## DEVELOPMENT APPLICATION ASSESSMENT REPORT

<b>Application Number:</b>	DA2022/0246
----------------------------	-------------

<b>Responsible Officer:</b>	DM Planning (independent planning consultant)
<b>Land to be developed (Address):</b>	Lot 9 DP 752046, 120 Prince Alfred Parade NEWPORT Lot 34 DP 13457, 120 Prince Alfred Parade NEWPORT Lot 35 DP 13457, 120 Prince Alfred Parade NEWPORT Lot B DP 391307, 120 Prince Alfred Parade NEWPORT Lot LIC 190387, 120 Prince Alfred Parade NEWPORT
<b>Proposed Development:</b>	Demolition works, subdivision of 4 lots into 2 lots and the construction of 1 dwelling on each lot including swimming pools and landscape works
<b>Zoning:</b>	C4 Environmental Living W1 Natural Waterways
<b>Development Permissible:</b>	Yes
<b>Existing Use Rights:</b>	No
<b>Consent Authority:</b>	Northern Beaches Council
<b>Land and Environment Court Action:</b>	No
<b>Owner:</b>	Bravo Futura Residential Development No. 1 Pty Ltd
<b>Applicant:</b>	Ella Maree Miles

This development application seeks consent for demolition works, subdivision of 4 lots into 2 lots and the construction of 1 dwelling on each lot including swimming pools and landscape works.

Description of non-compliance

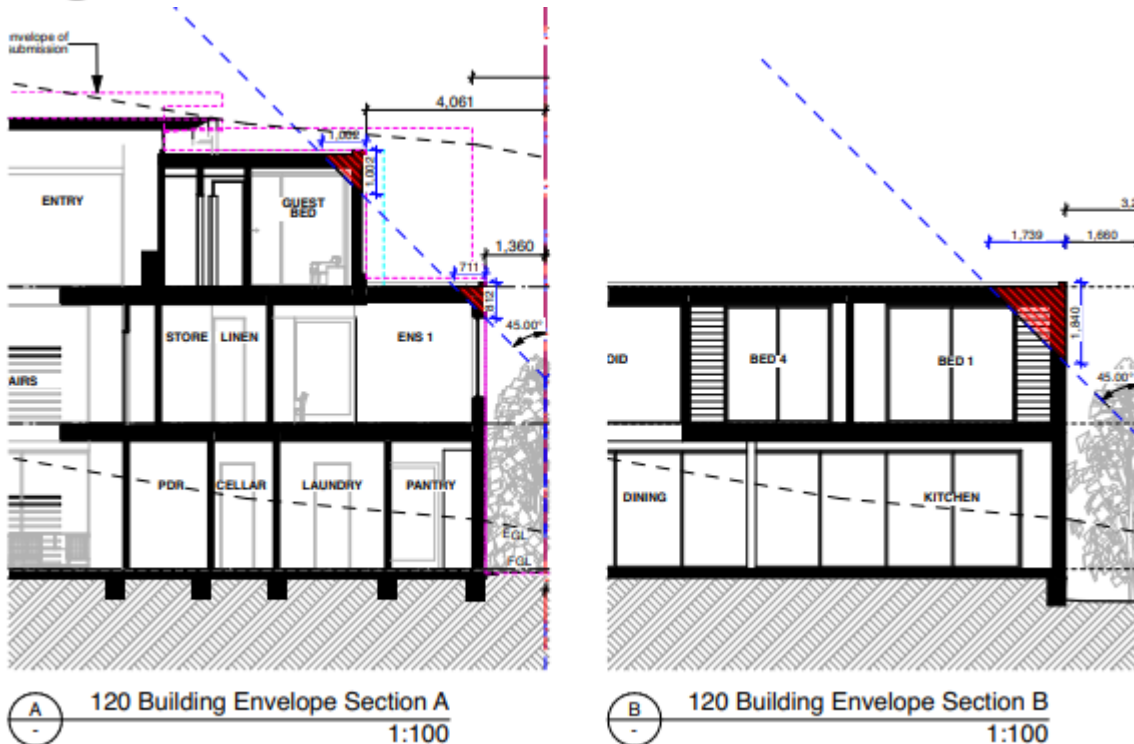
Clause 10.11 requires buildings to be sited within an envelope that measured 3.5m above ground level at the side boundaries and 45 degrees.

As shown in the sections above, the proposed dwelling at 120 Prince Alfred Pde, does not comply with the side building envelope along the eastern elevation. In this regard, the proposal involves a breach of 1m at the entry level and up to 1.84m at first floor level.
